Ref: Urgent Safety Information THERA-Trainer balo / THERA-Trainer verto

Movement therapy device – THERA-Trainer balo, THERA-Trainer verto

Picture: Broken hexagon socket set screw

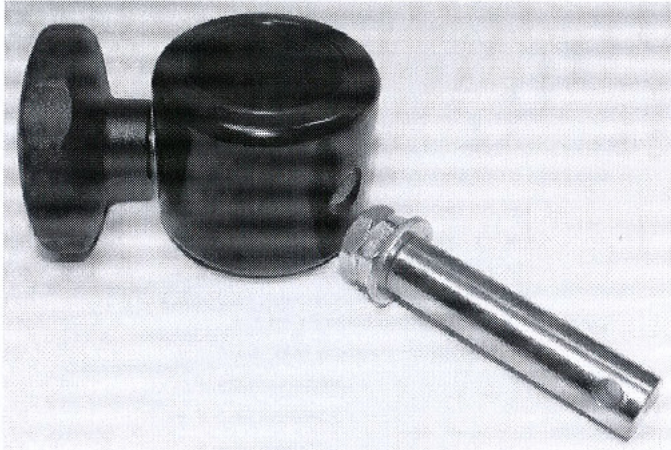
The hexagon socket set screw of the mounting mechanism of the knee support is broken.

As a cause, we detected a hydrogen embrittlement of the galvanized hexagon socket set screw with the strength ≥ 10.9 . This hydrogen embrittlement can occur irregularly. The damage can happen during low load already. If the hexagon socket set screw breaks, the knee support can fall of on one side and the patient will become instable during lifting process or during therapy.

- Please stop exercising with THERA-Trainer balo/THERA-Trainer verto until a modification was done.
- We, medica Medizintechnik GmbH, will send you within the next 2-3 weeks spare parts incl. service manual in order to exchange the relevant components. Please exchange the components and return the original components incl. the completed answer form to us.
